GENERAL LAND USE APPLICATION

| Case #: | Master File #: | Date: 7/2/18 JL | | |
|---|---------------------------|--|--|--|
| Project Name: Village At Mill Pon | | | | |
| Project Description: Amendments to the Design Criteria for the Village At Mill Pond - Master Plan. See attachment for proposed amendments. | | | | |

The Village At Mill Pond Design Guidelines - Explanations

ATTACHMENT 1-A

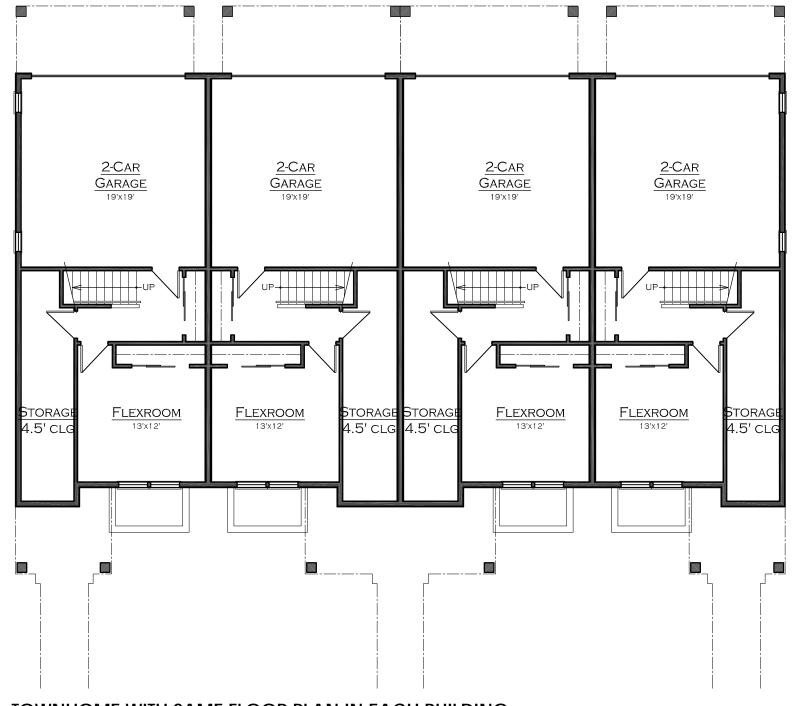
Homes should have significant variations in the floor plans, which allows for variety in the massing of the home, with the exception that townhomes may have the same floorplan within each building.

This is a clarifying addition to the design criteria. Currently duplex, triplex & quadruplex style townhomes are part of the master plan development. Each unit within the townhome buildings will be repeated which allows for consistency in exterior appearance, economy in construction, and clarity in design. The goal of providing variety in buildings & units is maintained through compliance with other design guidelines for this development.

See attachment 1-A, 1-B and 1-C for floorplan examples of townhomes with similar floorplans.

ATTACHMENT 2-A

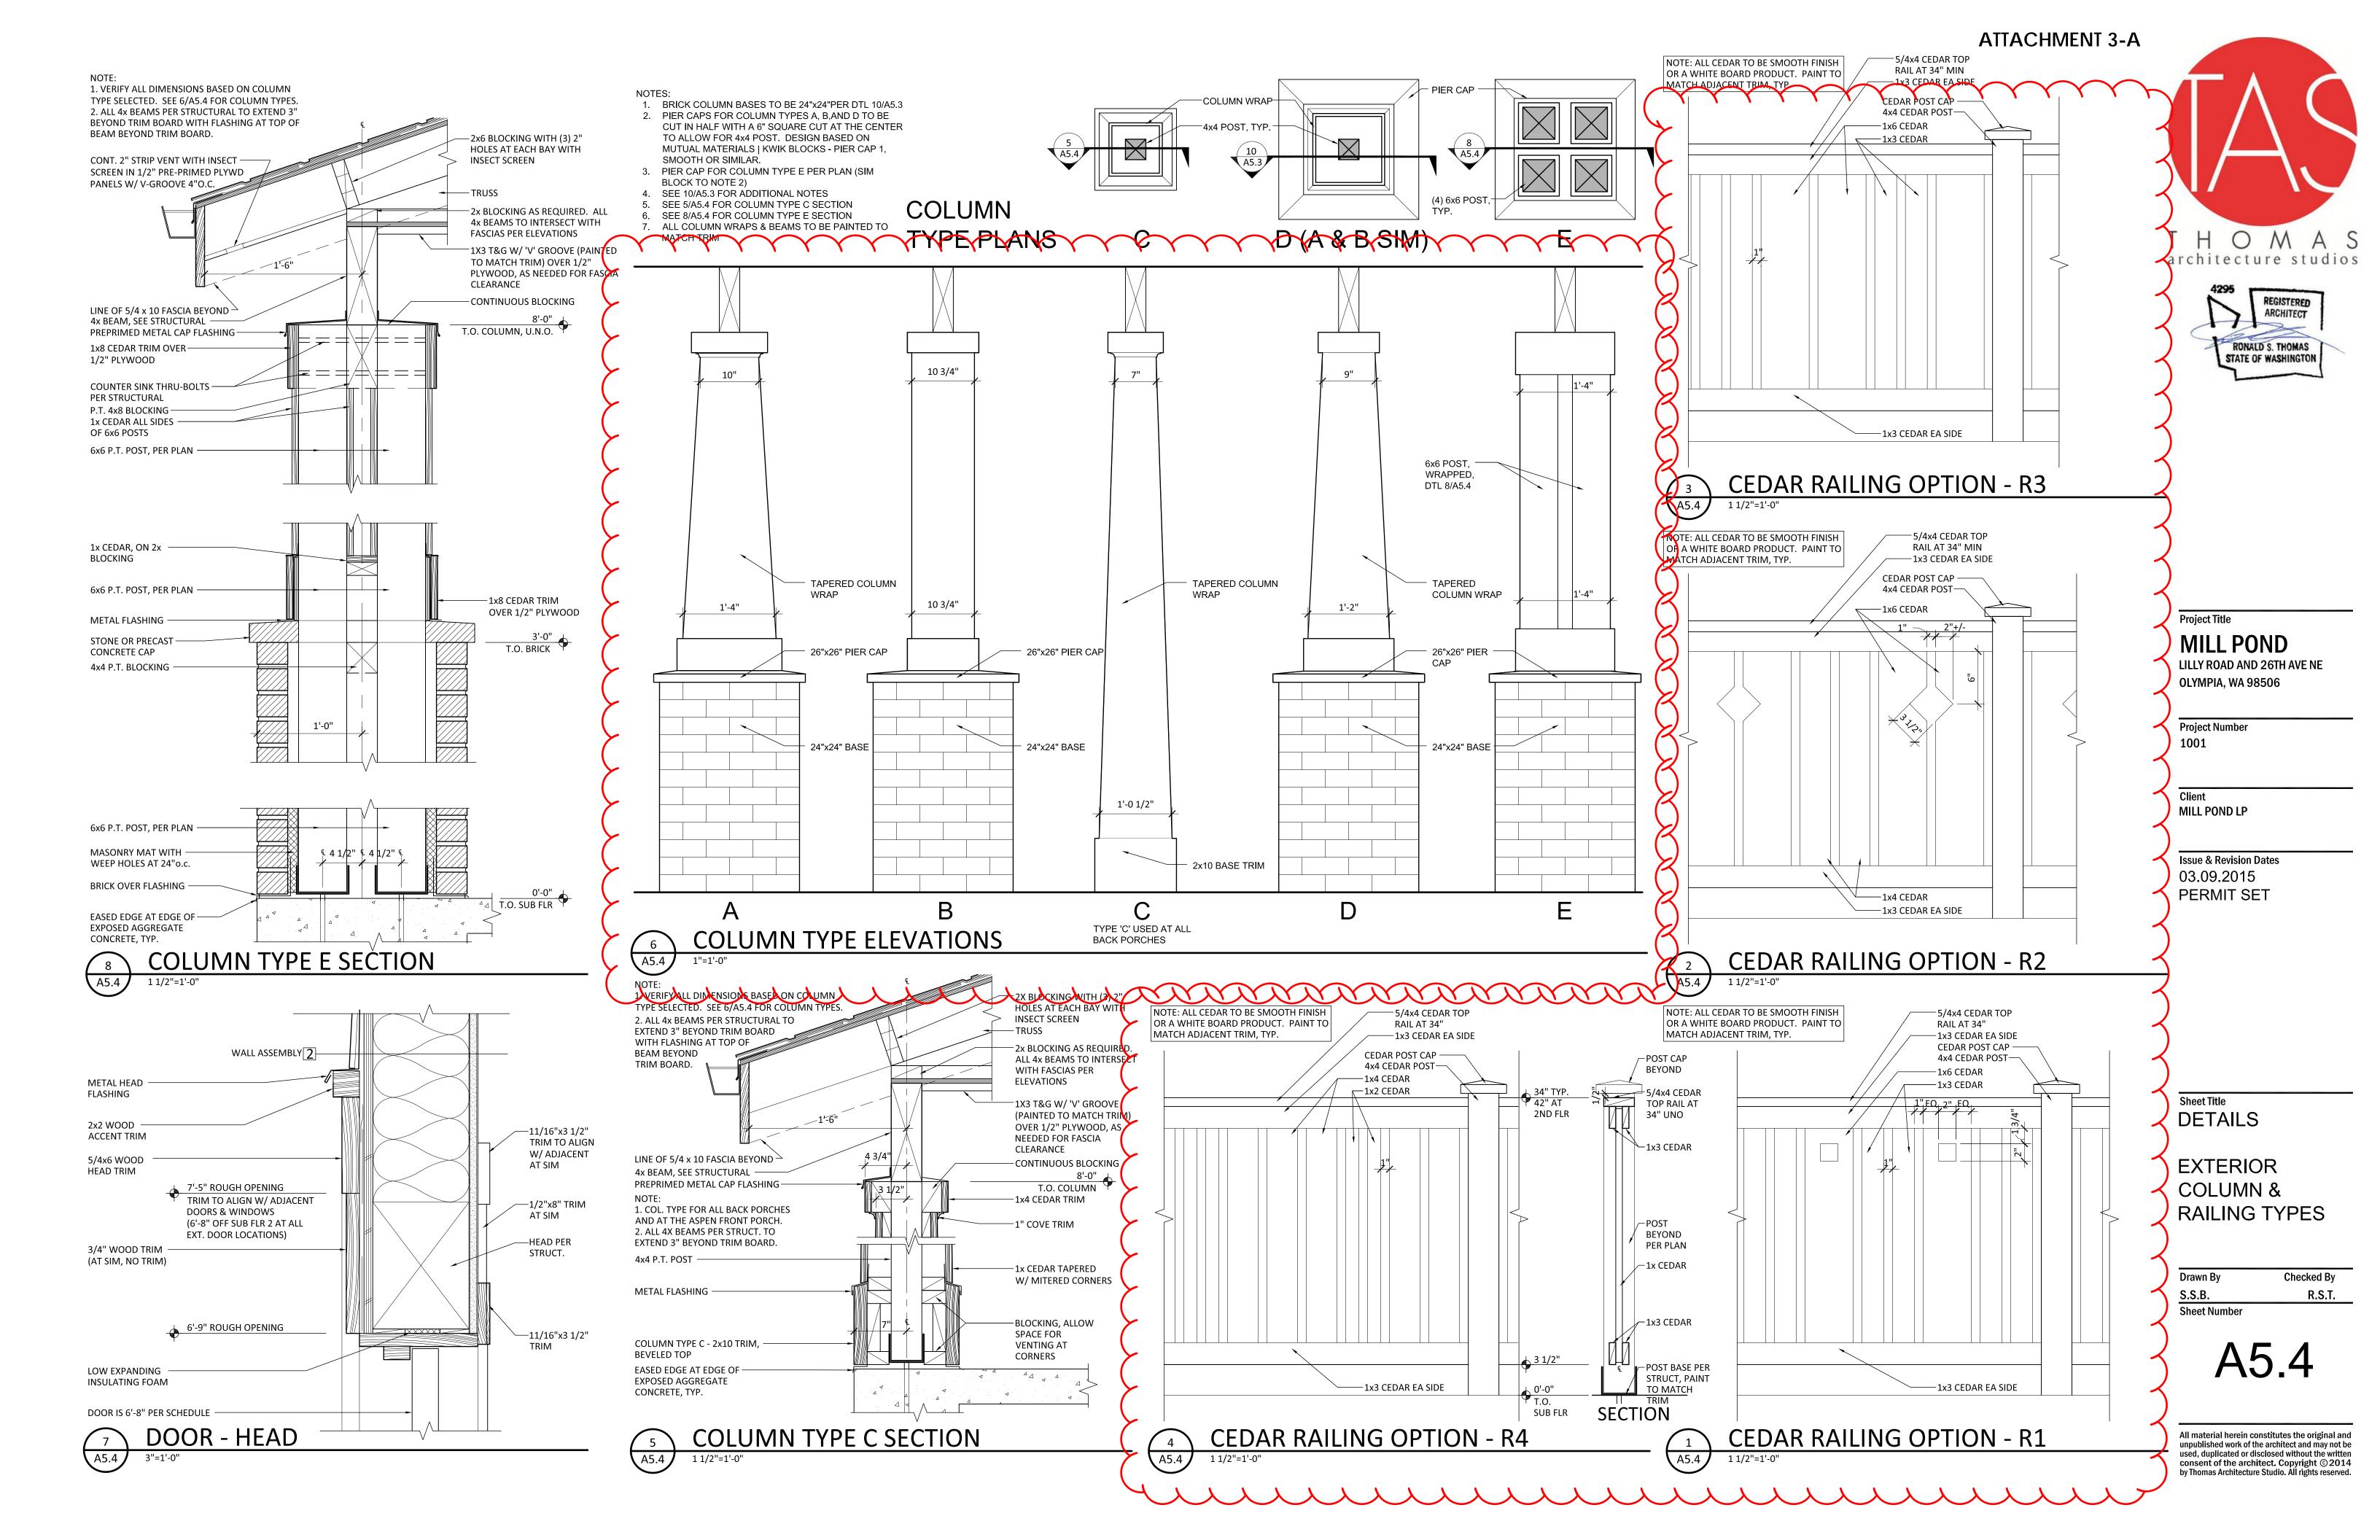
• No more than two of the same model and elevation will be built <u>within six continuous</u> <u>lots.</u> within eight <u>contiguous</u> lots.

There are currently 12 different single-family model options to choose from at the Village at Mill Pond. The current 2 per 8 contiguous lot requirements does not provide for flexibility in market demand. Inevitably there are certain models that are more popular among prospective home buyers. Revising the contiguous requirement from 8 to 6 would create more options for development and accommodate pre-selling lots with a desired model type that is contrary to the original layout.

See attachment 2-A site plan example of one model configured in a 2 per 8 contiguous lot layout and another model in 2 per 6 contiguous configurations.

ATTACHMENT 5-A

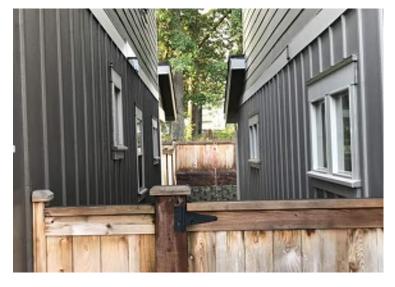
Any vertical changes in materials in a vertical wall, such as from brick to wood, shall
wrap the corners no less than 24 inches. The material change shall occur at an
internal corner or a logical transition such as aligning with a window edge or
chimney.

The term "Logical transition" is subjective and should be removed. The intent of providing nicer materials along the front façade while eliminating awkward outside corner transitions in materials would be achieved as long as materials return at least 24" along each side of the house.

See Attachment 5-A for an example of vertical changes in materials See Attachment 5-B for an example of corner transition in existing site

ATTACHMENT 5-B

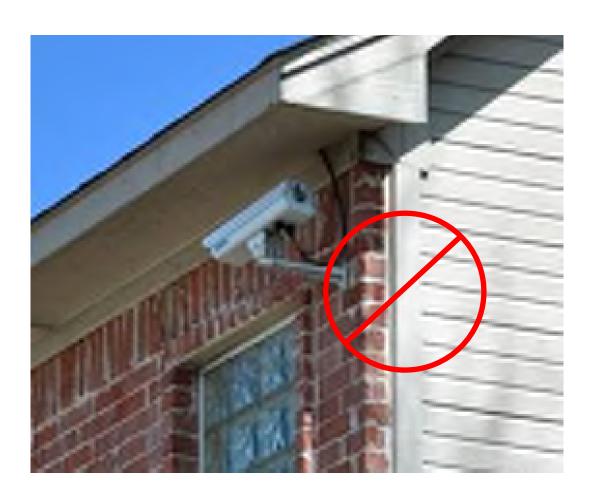
Any horizontal transition in material on a wall surface, such as shingle to lap siding, shall have a material separation, such as trim band board. <u>Brick or cultured stone are considered a material separation</u>. <u>Trim band boards are not required at horizontal</u> <u>brick or stone transition</u>.

Brick & stone are materials that further enhance the appearance of the home, their nature and thickness allow them to act as a transition piece without the need for trim board. The 2-3 inches in material thickness provide a variety in depth and provide a break in the surface plane of the exterior elevation eliminating the need for a material change trim board.

See Attachment 6-A for an example of horizontal transition in materials without the trim band board in existing site

ATTACHMENT 7-A

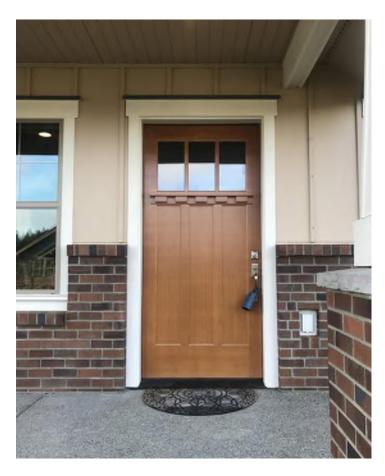
Front doors shall be made of vertical grain fir (finished to allow natural wood to show)
 <u>or insulated fiberglass with a wood texture and painted finish</u>; all other doors shall be
 made of wood, insulated fiberglass, or insulated metal.

- -Garage doors already include the use of fiberglass in required criteria so this addition would be consistent with the current design criteria for the Village at Mill Pond.
 - Garage doors may be wood, insulated fiberglass, or insulated metal.
- -Painted fiberglass doors add to variety and color within the development.
- -Fiberglass doors are more durable and have a longer-lasting finish.
- -Fiberglass doors provide a similar look and appearance to wood doors.

ATTACHMENT 12-A

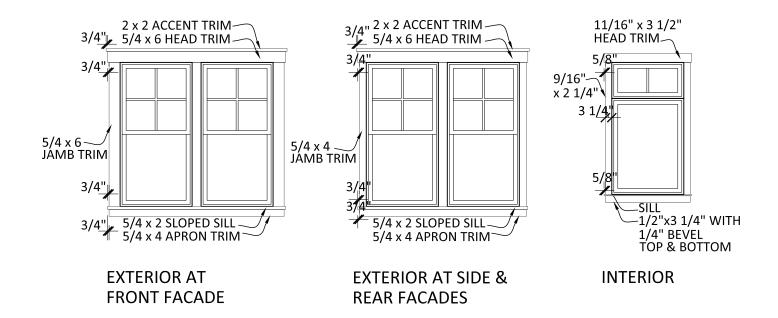
- Removal of unclear sentence. This implies all models to get bay window. Windows will be trimmed out on all four sides and installed in plane with wall.
- See attachment 12-A Window Trim for example of how this criteria is addressed in existing site.

ATTACHMENT 13-A

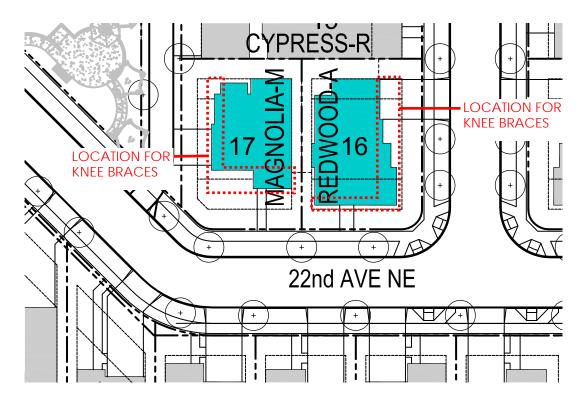
- Clarifying extent of architectural detail does not extend to sides or back of house, which have little to no visibility from the street. This addition to the criteria still achieves the cohesive 'feel' of the development and meets the intent.
- Houses on corner lots or adjacent to public open spaces would still need to meet this requirement.
